GENERAL INFORMATION

Applicant:	Aeon VP Bloomington, LLC (Owner and Developer)
Location:	1900 East 86 th Street
Request:	1) Rezoning from R-4 Multiple-Family Residential to RM-24(PD) High Density Residential (Planned Development). 2) Preliminary Development Plans and Final Development Plans to add 172 new residential units in two four-story multi-family residential apartment buildings to an existing multi-family residential site.
Existing Land Use and Zoning:	Multiple family residential – apartments; zoned R-4 Multiple Family Residential
Surrounding Land Use and Zoning:	North – Hotel and office; zoned C-4(PD) South – Single-family residential; zoned R-1 East – Townhomes and fire station; zoned R-4, R-4(PD) and R-1 West – State Highway 77
Comprehensive Plan Designation:	High Density Residential

Case PL2020-69

Project Description: Rezoning from R-4 to RM-24(PD), Preliminary Development Plans, and Final Development Plans to add 172 new residential units in two four-story multi-family residential apartment buildings to an existing multi-family residential site.

Figure 1: Rezoning from R-4 to RM-24(PD)

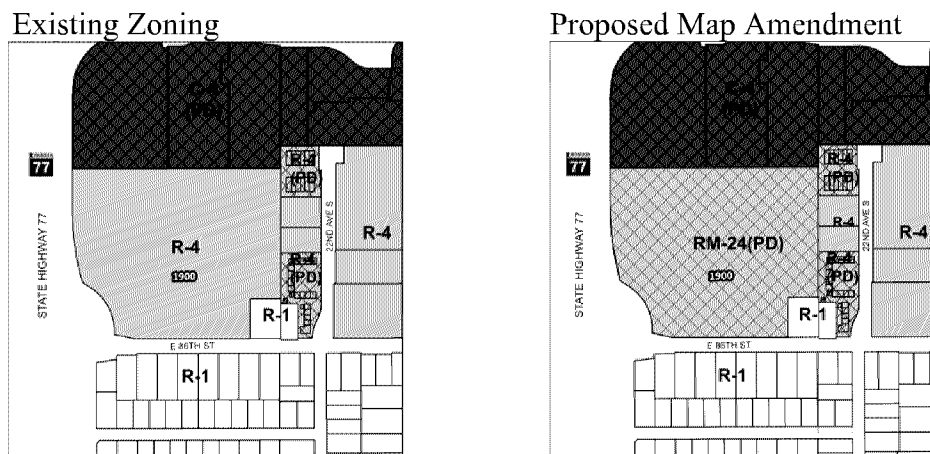
To allow for the expansion of the existing multi-family residential development, the applicant requests rezoning the property from R-4 to RM-24(PD), as shown in Figure 1. The total number of dwelling units proposed would comply with the maximum density restrictions of the RM-24 zoning district when factoring in density bonuses permitted within the Opportunity Housing Ordinance (Sec. 9.16). The maximum density allowed in the RM-24 zoning district is 24 units per acre. Given the site area of 17.67 acres, a typical residential development could have a maximum number of 424 units or dwellings under the RM-24 zoning designation. However, the OHO would allow 138 bonus dwelling units above the maximum density as a result of the affordable units provided. More information about this calculation can be found in the Opportunity Housing Ordinance section that follows. As a result, this site could have 568 dwelling units based upon the quantity of affordable units proposed. The proposed quantity of 478 apartments would be compliant with the RM-24 base zoning designation in light of the OHO density bonus tool.

A rezoning action has a high level of City Council discretion. Although there are no explicit findings that must be made in conjunction with a rezoning, appropriate considerations include the following:

- Whether the proposed district is consistent with the Comprehensive Plan;
- How the proposed district differs from the existing district; and
- Whether there is a public benefit from the change.

In terms of consistency with the Comprehensive Plan, the subject property is designated High Density Residential. The High Density Residential designation is intended for residential properties with a residential density greater than 10 units per acre. In addition, the intent of the RM-24

District is to “provide appropriate development standards for multiple-family residential uses with access to arterial or collector streets in proximity to neighborhood commercial uses and public open space.” The subject property abuts East 86th Street, a major collector roadway, and State Highway 77, a principal arterial. The site is in proximity to neighborhood commercial uses along the East Old Shakopee Road corridor and the Mall of America. Wright’s Lake Park and Bass Ponds trail head provide nearby opportunities for public open space and recreation. Transit service (local routes 538A and 539B) is available on East 86th Street, as well as the Metro Blue Line LRT at Mall of America Station.

The R-4 zoning district, the current zoning of the subject property, is the zoning district that was historically applied to multiple-family residential properties in Bloomington when the site was developed. As multi-family residential properties develop or expand, it is common for sites to be rezoned to accommodate the residential density proposed, provided the proposed uses are consistent with the Comprehensive Plan. The proposed zoning district, RM-24, allows for a higher residential density desired by the applicant. The maximum residential density of the existing R-4 zoning district is 12 units per acre, whereas the RM-24 district allows 24 units per acre. Rezoning to the RM-24 zoning district is necessary to allow for the expansion of the existing multi-family residential campus, as the existing density of the site is already above what is permitted in the R-4 district.

To evaluate the public benefit associated with the requested zoning change, staff references the Comprehensive Plan to verify the proposed project is consistent with the City’s land use and housing goals. The Comprehensive Plan Housing Element encourages development of multi-family housing on sites near transit, services, amenities and employment. In addition, the Housing Element supports the development of life cycle housing. New multi-family residential development is a critical component of the diverse housing stock needed to achieve life cycle housing in the community. Both the Comprehensive Plan and the One Bloomington Strategic Plan also support the creation of additional affordable housing. The proposed rezoning supports multiple goals of the Comprehensive Plan and Strategic Plan and will benefit the public. Staff recommends approval of the request to rezone the property from R-1(PD) to RM-24(PD).

In Case #PL2020-69, I move to adopt an ordinance rezoning 1900 East 86th Street from R-4 to RM-24(PD).
